# NOTICE OF DECISION

## DECISION OF THE PLANNING ADMINISTRATOR

**SUBDIVISION TENTATIVE PLAN / URBAN GROWTH PRELIMINARY  
DECLARATION / CLASS 3 SITE PLAN REVIEW / CLASS 2 ADJUSTMENT /  
TREE VARIANCE / CLASS 1 DESIGN REVIEW CASE NO.: SUB-UGA-SPR-ADJ-  
TRV-DR23-02**

**SUMMARY:** A proposed six-lot subdivision for Titan Hill Estates in conjunction with a proposed multi-family development of 436 units for Titan Hill Apartments.

## SDR3

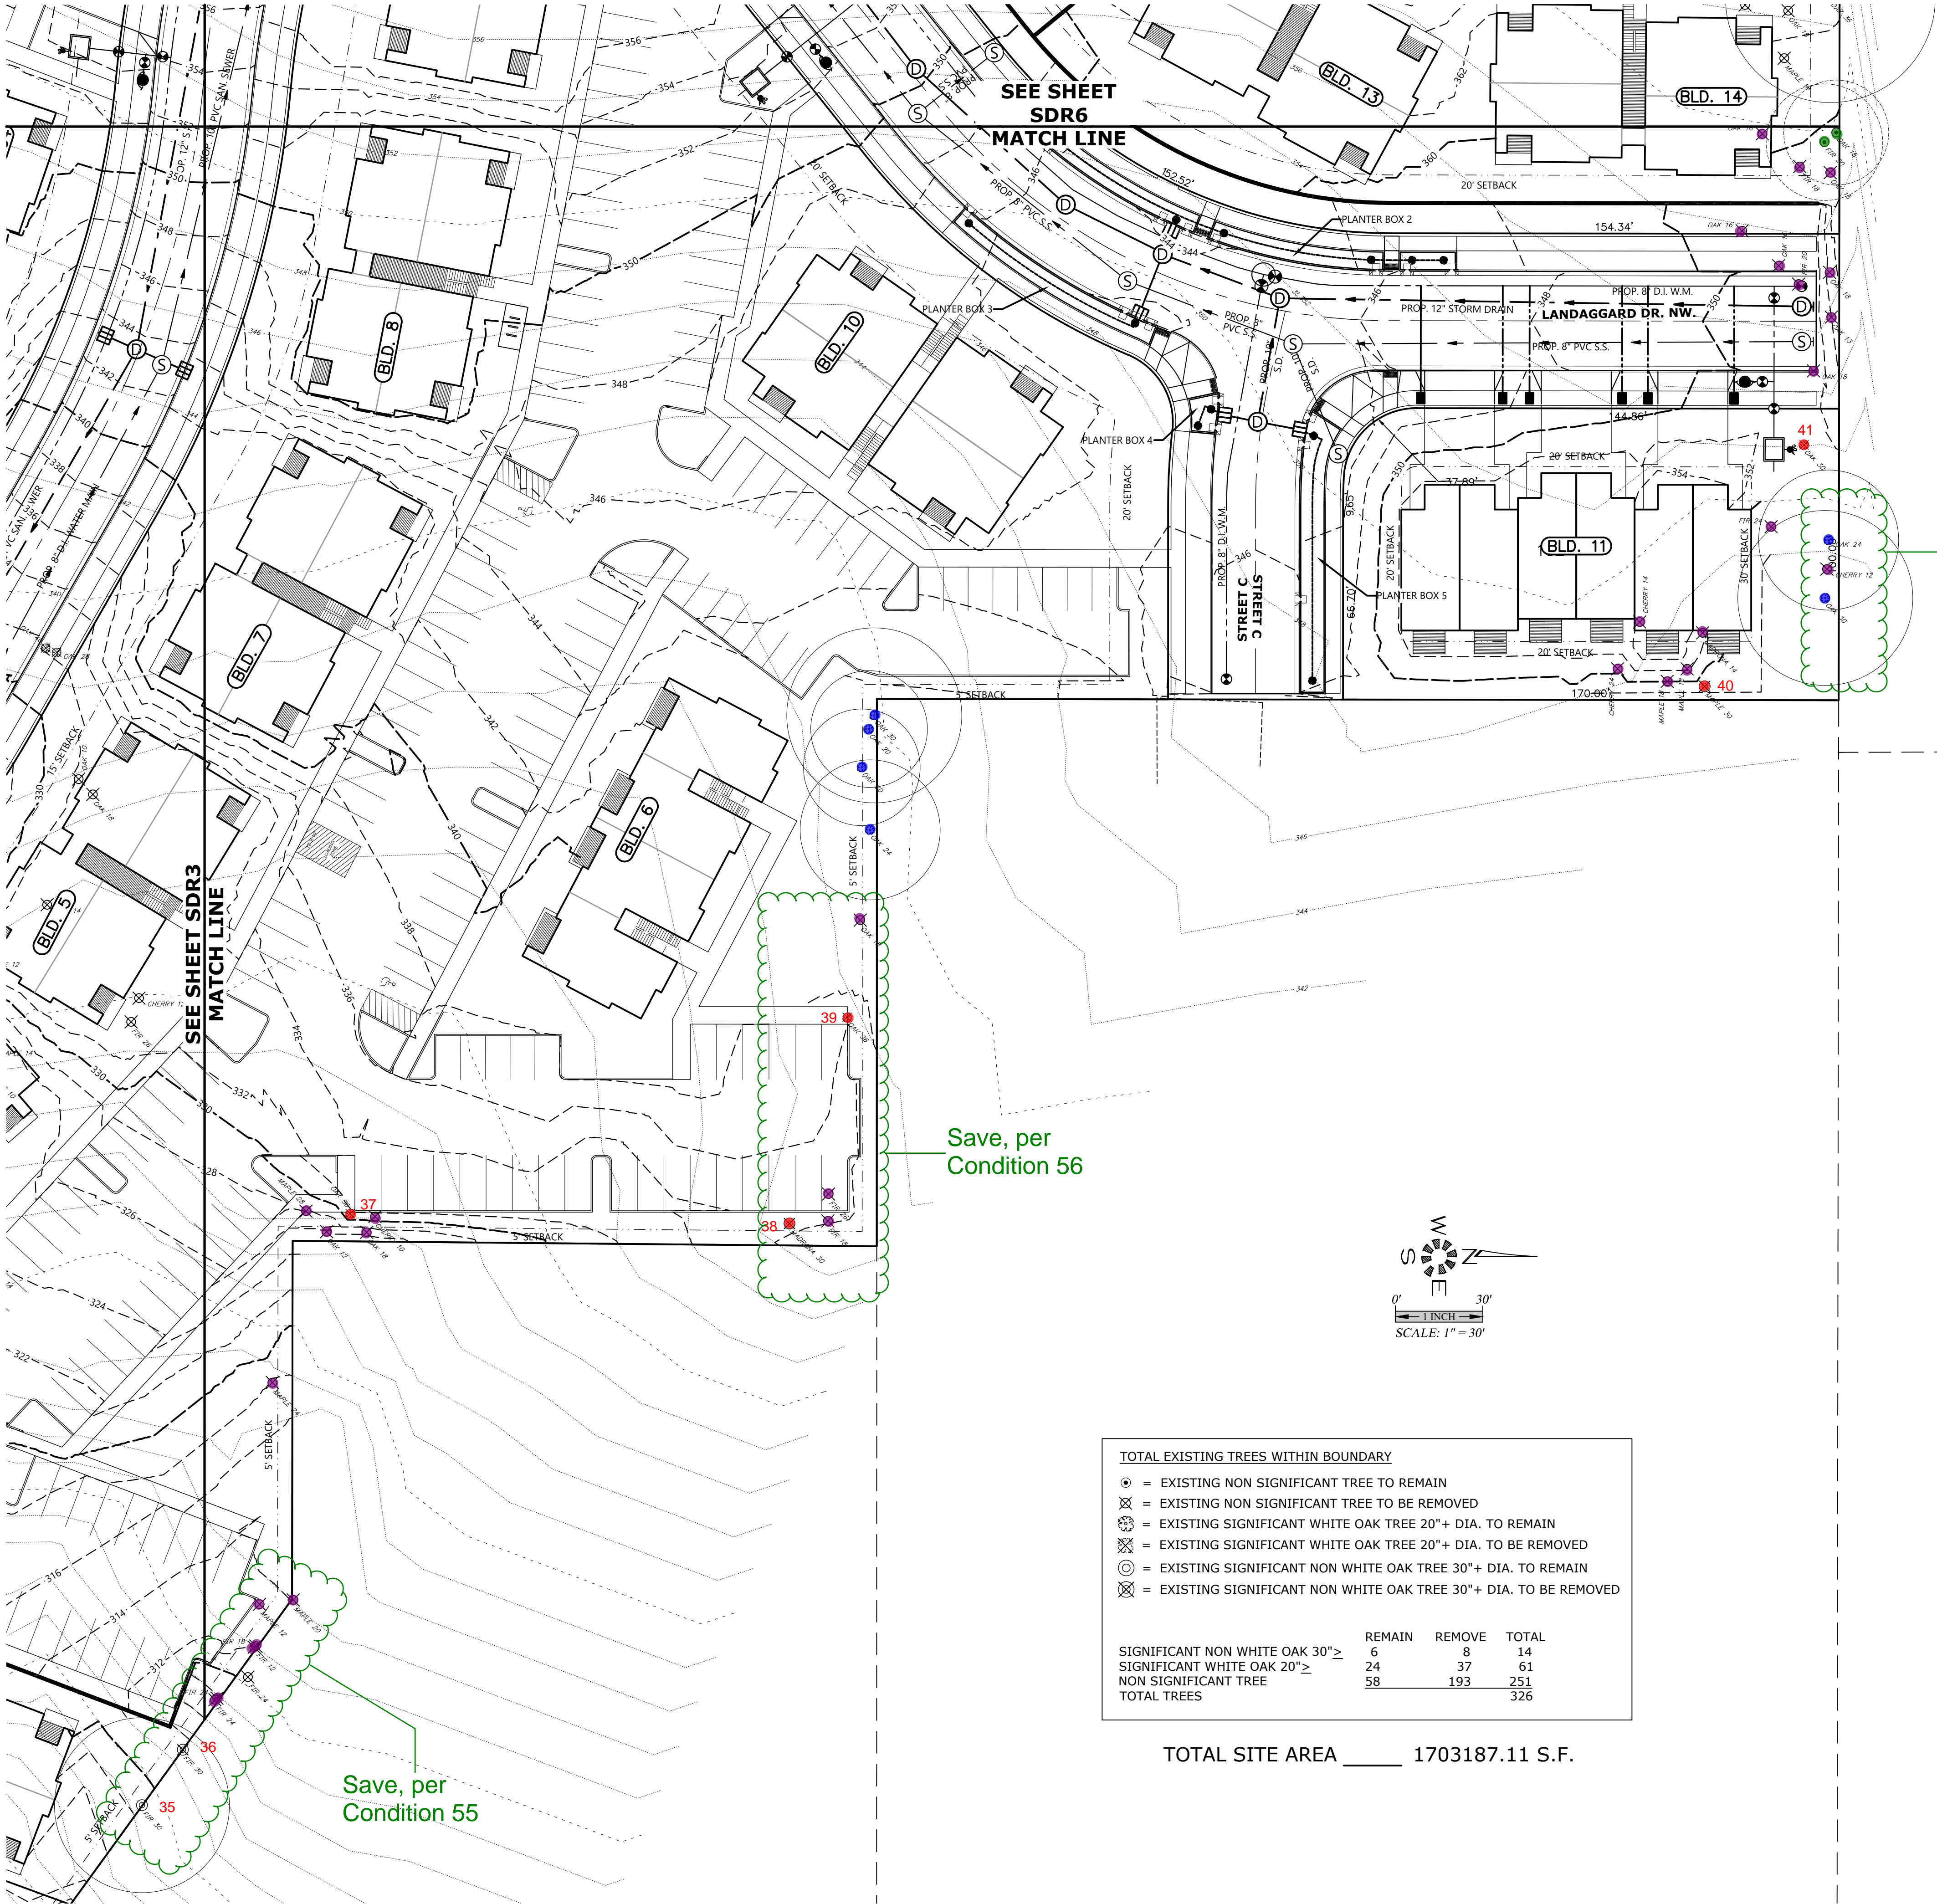
Save, per  
Condition 5

OK to remove for street realignment
